**SAS SUPERSTRUCTURE - CONDUIT AND CABLE TRAY PLAN**

CONTRACT CHANGE ORDER NO. 42  
 SHEET \_\_\_\_ OF \_\_\_\_

**SAS SUPERSTRUCTURE GIRDER WESTBOUND LIGHTING AND ELECTRICAL SYSTEMS**

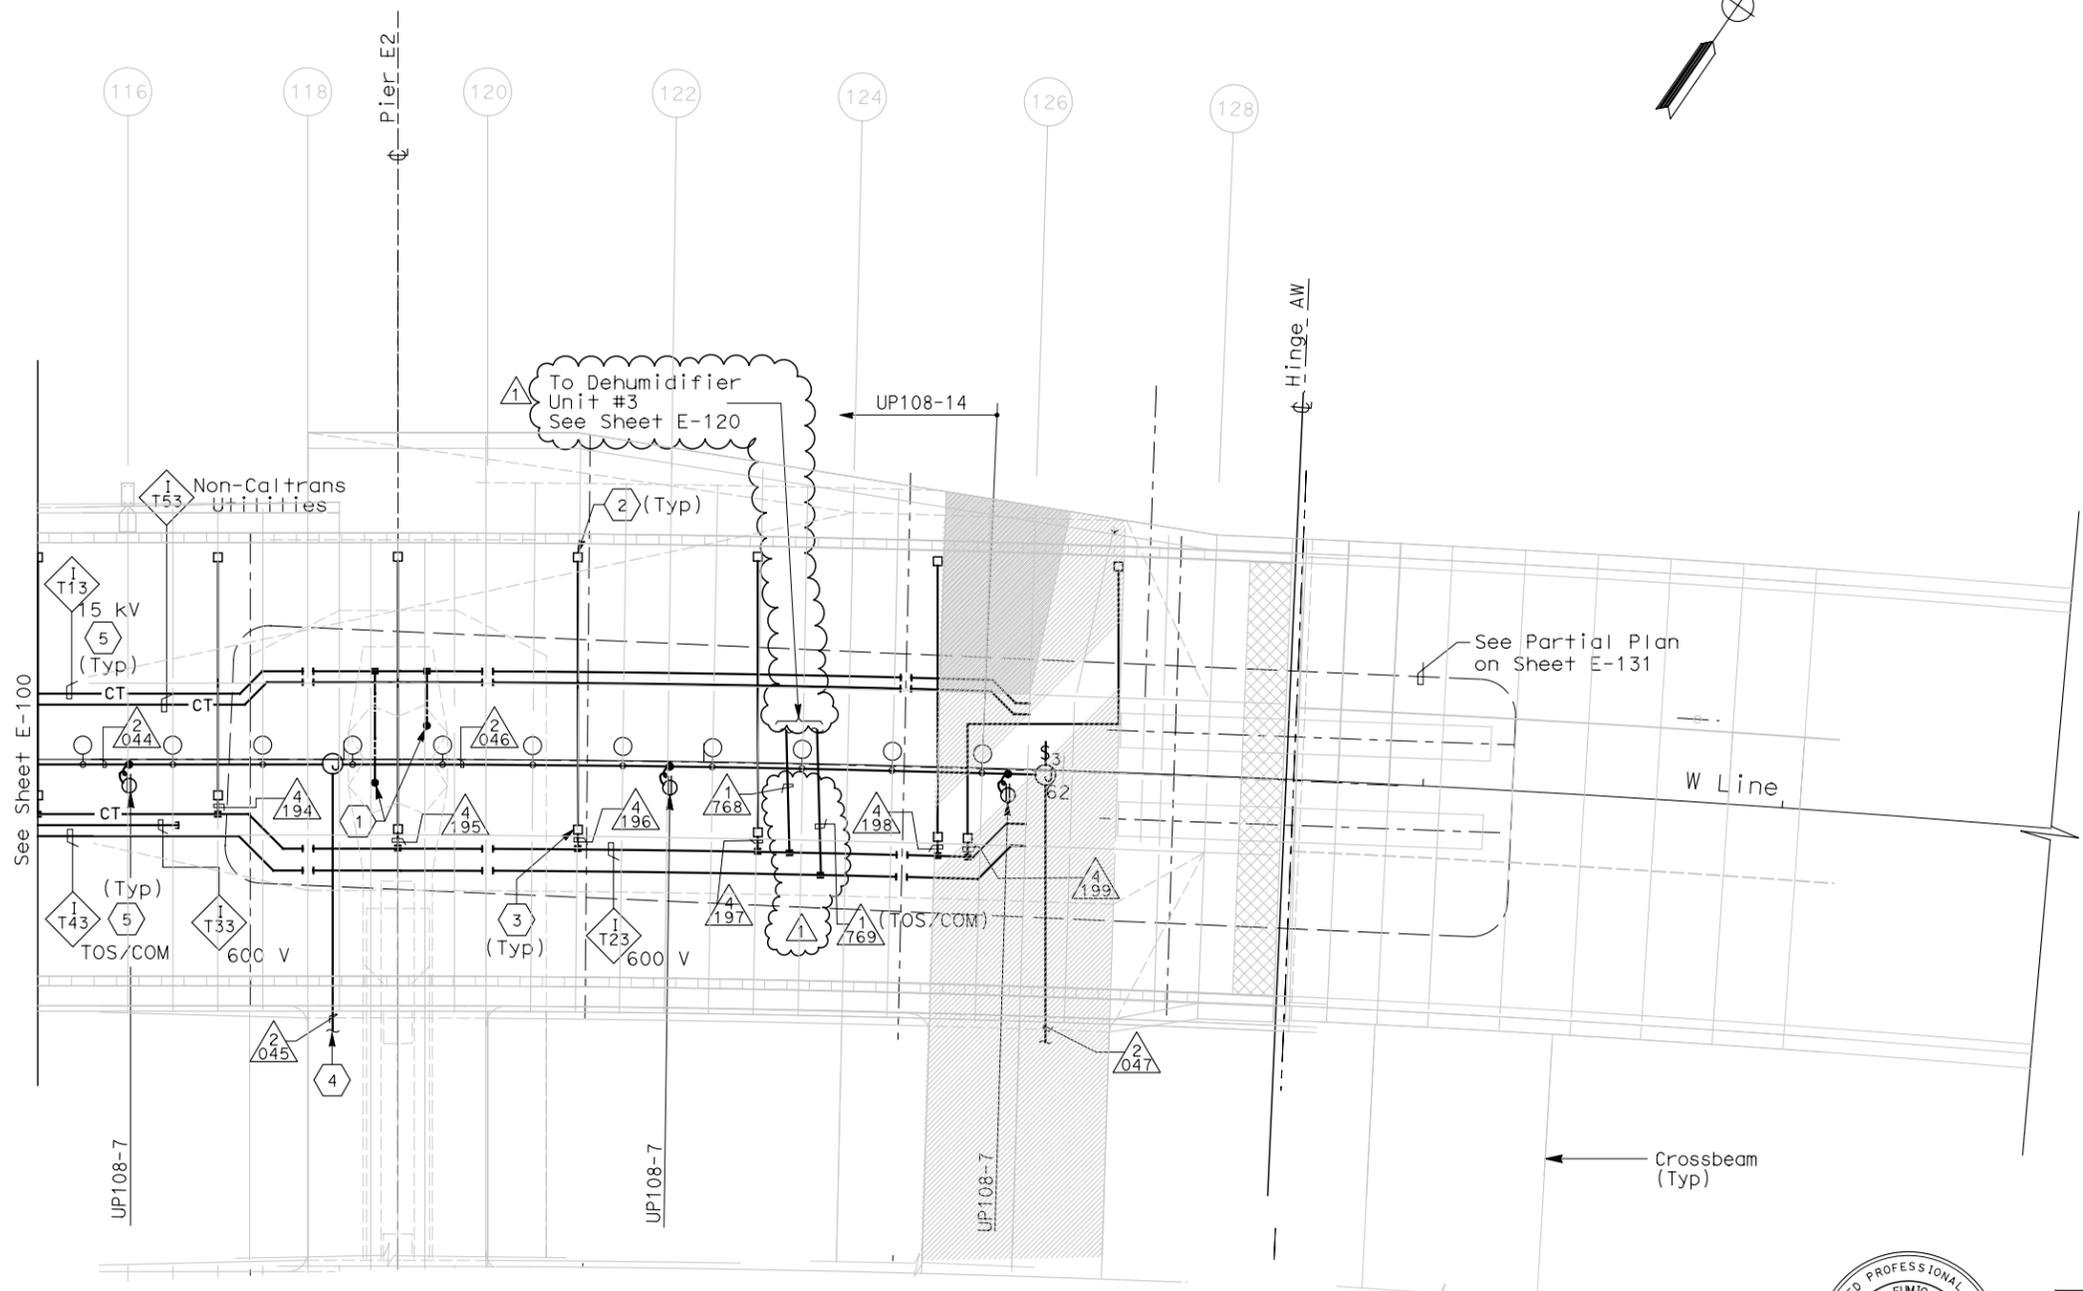
MARK	DATE	DESCRIPTIONS	BY	CK	CCO
△	8/6/07	Electrical modifications.	MP	RR	42
REVISIONS
